METROPOLITAN GOVERNMENT OF NASHVILLE AND DAVIDSON COUNTY

STAFF RECOMMENDATION 1703 Primrose Avenue May 15, 2013

Application: Partial Demolition; New Construction—Addition and Outbuilding
District: Belmont-Hillsboro Neighborhood Conservation Zoning Overlay
Council District: 18
Map and Parcel Number: 11708005300
Applicant: Van Pond Architect, PLLC
Project Lead: Melissa Baldock, melissa.baldock@nashville.gov

<p>Description of Project: Application is to demolish an existing rear addition and construct a new side porch, rear addition, and outbuilding.</p> <p>Recommendation Summary: Staff recommends approval of the project with the condition that staff review the asphalt shingle color and the specifications for all windows and doors prior to purchase and installation. With this condition, staff finds that the project meets Sections II.B.1., II.B.2., and III.B.2. of the <i>Belmont-Hillsboro Neighborhood Conservation District: Handbook and Design Guidelines</i>.</p>	<p>Attachments A: Photographs B: Site Plan D: Elevations</p>
---	--

② Proposed Site Plan
 SCALE 1/8" = 1'-0"

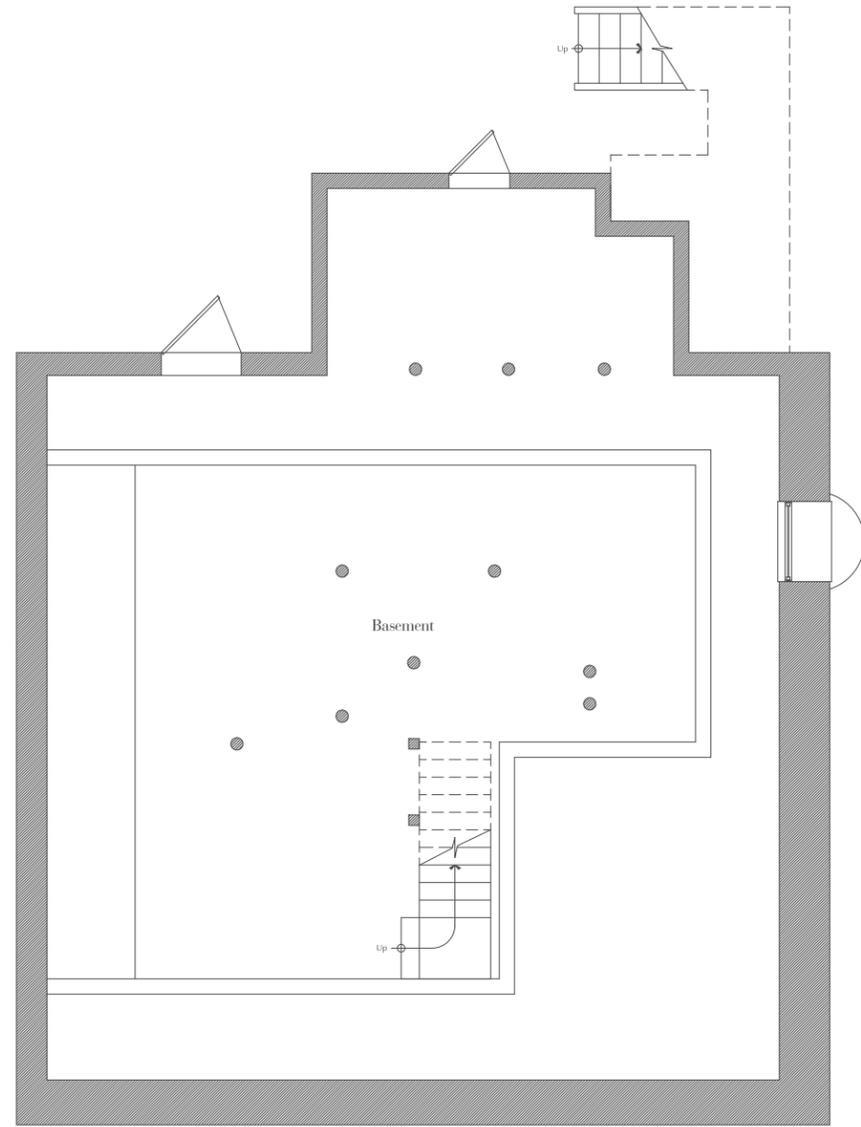
Location, Setback: The proposed addition and the outbuilding meet all base zoning requirements for setbacks. The addition is largely located behind the historic house, with the exception of seven foot by nine foot (7'X9') covered deck located at the back left corner of the house that extends six feet (6') beyond the sidewall of the house. Staff finds that this side addition meets the design guidelines for several reasons. The lot is over eighty-seven feet (87') wide, which is unusually wide for the area, making a side addition appropriate. In addition the side addition is modestly scaled. It only extends six feet (6') beyond the wall of the historic house and its ridge height is fifteen feet, nine inches (15'9"), which is significantly lower in height than the historic house. Also, the addition preserves the back corner of the house and is open in nature, thereby lessening its impact on the historic house.

Staff finds that the location and setback of the addition meets Sections II.B.1.c and II.B.2. of the *Belmont-Hillsboro Neighborhood Conservation Zoning Overlay: Handbook and Design Guidelines*.

Outbuilding: An outbuilding is proposed for the rear of the property. The structure will be three feet (3') from the left property line and at least ten feet (10') from the rear property line at its closest point, thereby meeting all base zoning requirements for

① Main Floor Demo Plan
 SCALE 1/4" = 1'-0"

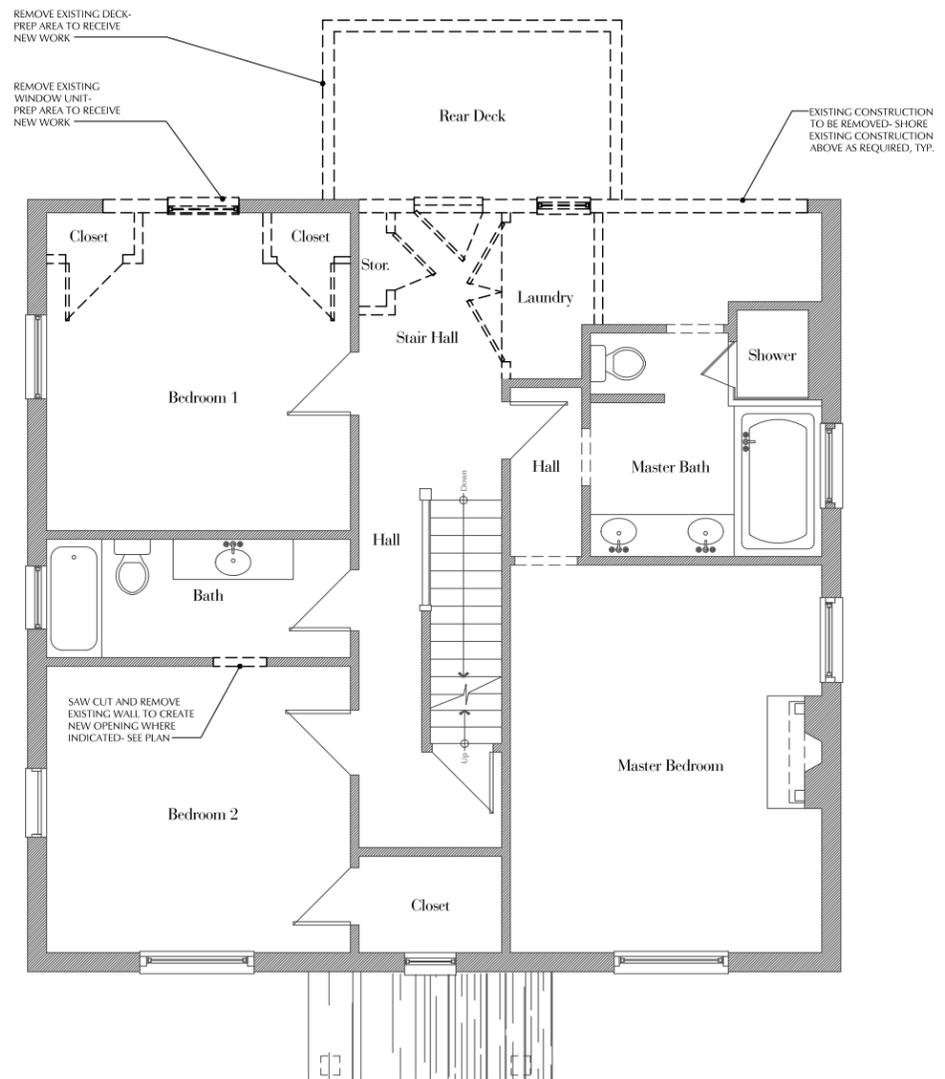
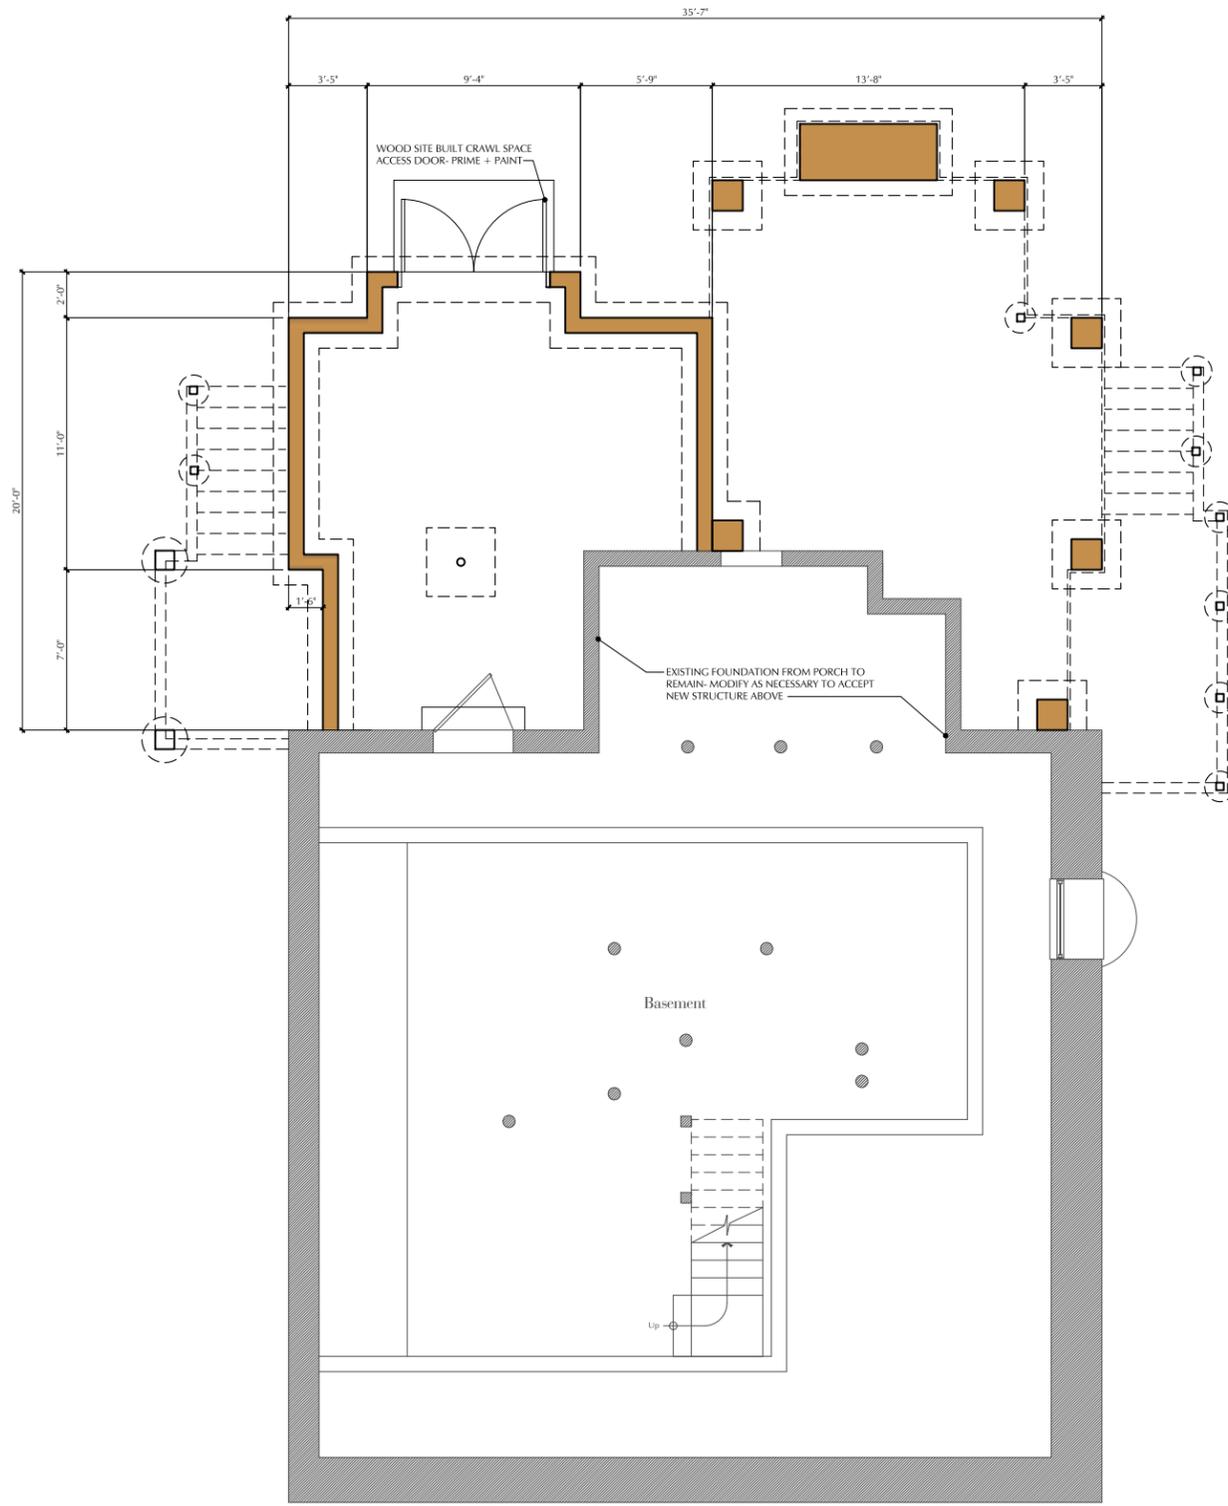
Partial Demolition: The application involves demolishing an existing rear addition to the house (see Figure 2). Staff finds that the existing addition does not contribute to the historic character of the house or the district and that its removal meets the design guidelines. The proposed rear addition also requires removing portion of the back wall of the historic house. Enough of the back wall will remain to preserve the original form of the house and to ensure that if the addition is removed in the future, the back corners of the house will

be extant. Staff finds that the rear façade does not have any character-defining features. Therefore the removal of portions of the back wall meets the design guidelines. Staff finds that the removal of the existing addition and portions of the back wall of the house meet Section III.B.2. of the *Belmont-Hillsboro Neighborhood Conservation Zoning Overlay: Handbook and Design Guidelines*.

① Garage Plan
SCALE 1/4" = 1'-0"

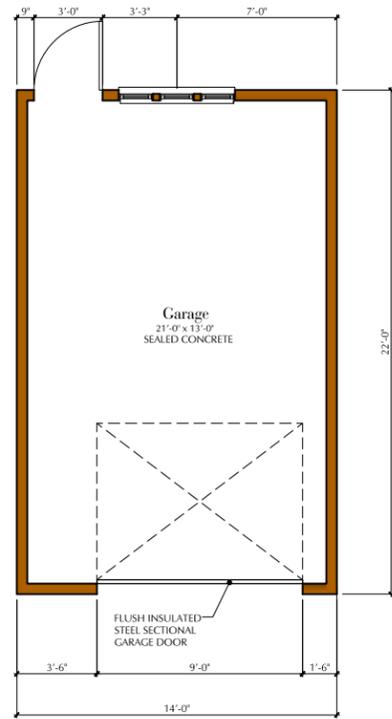
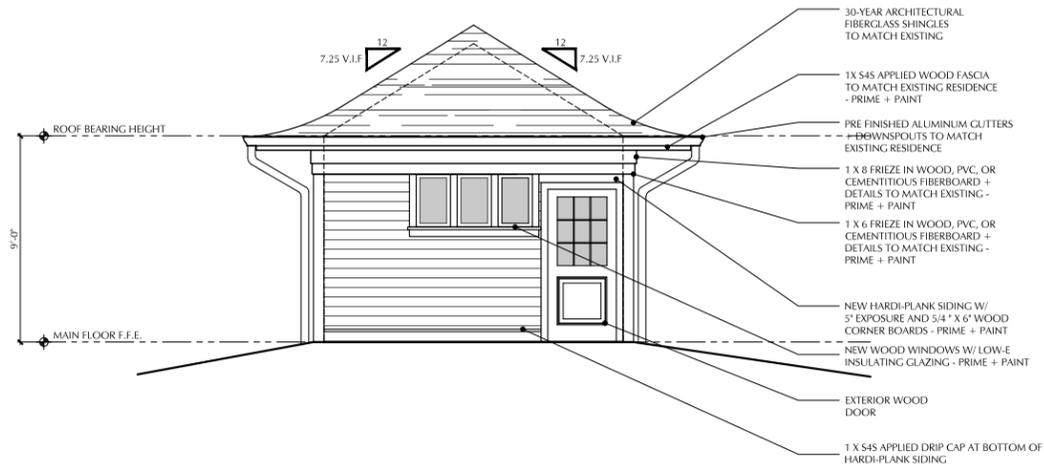
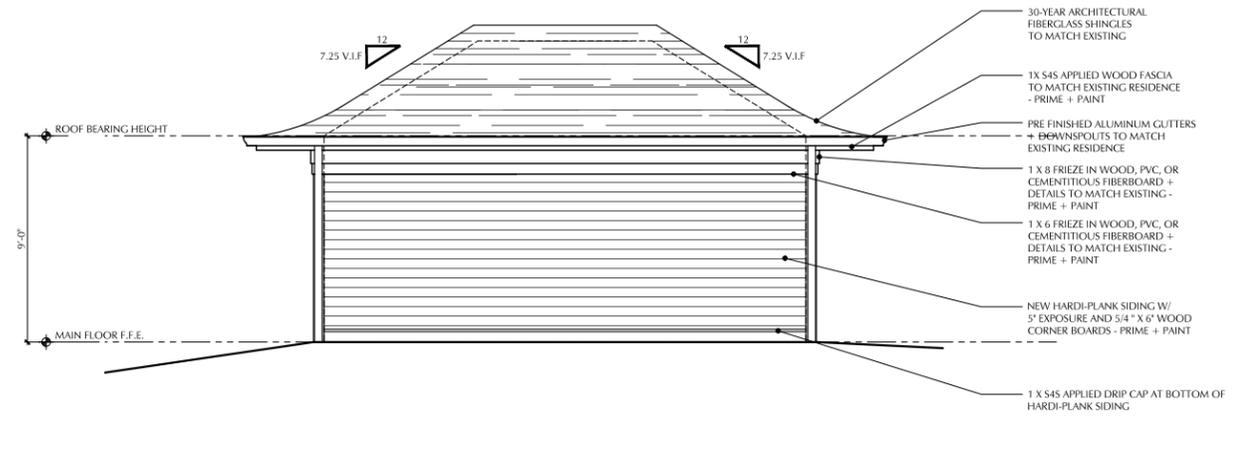
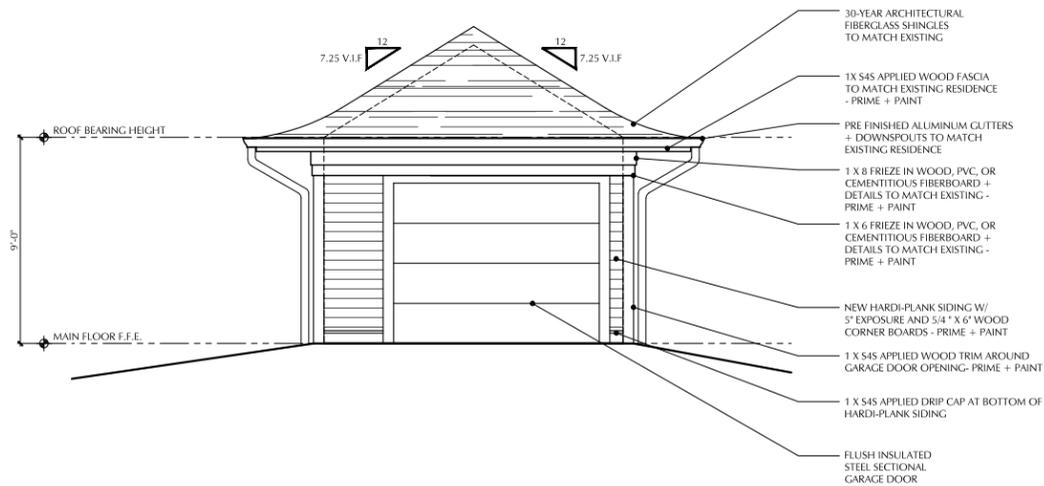
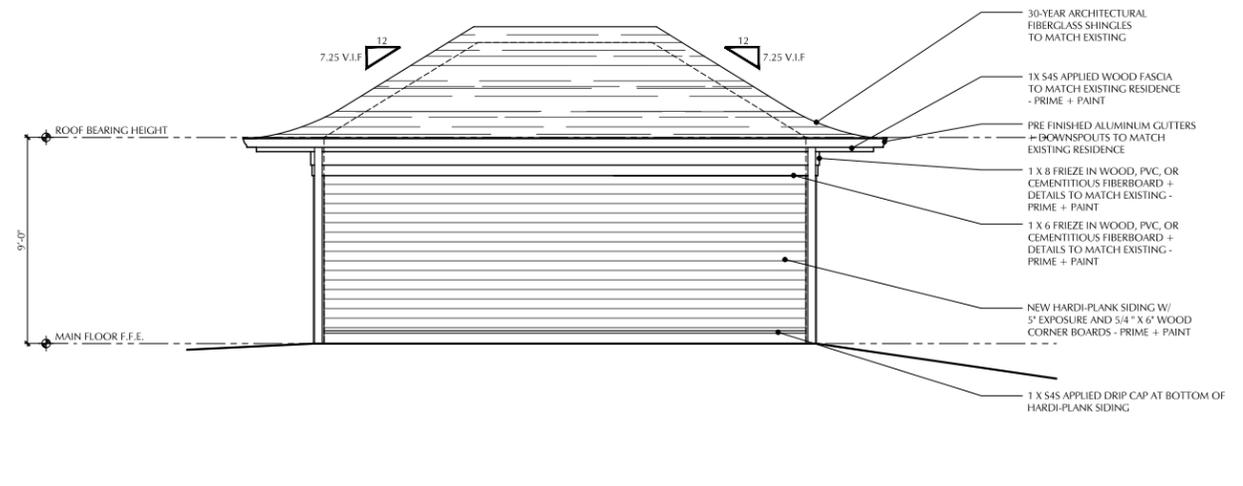
setbacks. The outbuilding will be fourteen feet (14') wide and twenty-two feet (22') deep. It has an eave height of approximately nine feet (9') above grade, and a ridge height of approximately fourteen feet (14'). Its hipped roof will have a slope of 7.25/12. Its materials are similar to the materials for the addition: cement fiberboard siding, fiberglass shingles, wood trim, wood pedestrian door, and wood windows. The garage doors will be steel. The structure's proportion and rhythm of openings are appropriate for a historic structure.

Staff finds that the outbuilding meets Section II.B.1.i. of the *Belmont-Hillsboro Neighborhood Conservation Zoning Overlay: Handbook and Design Guidelines*
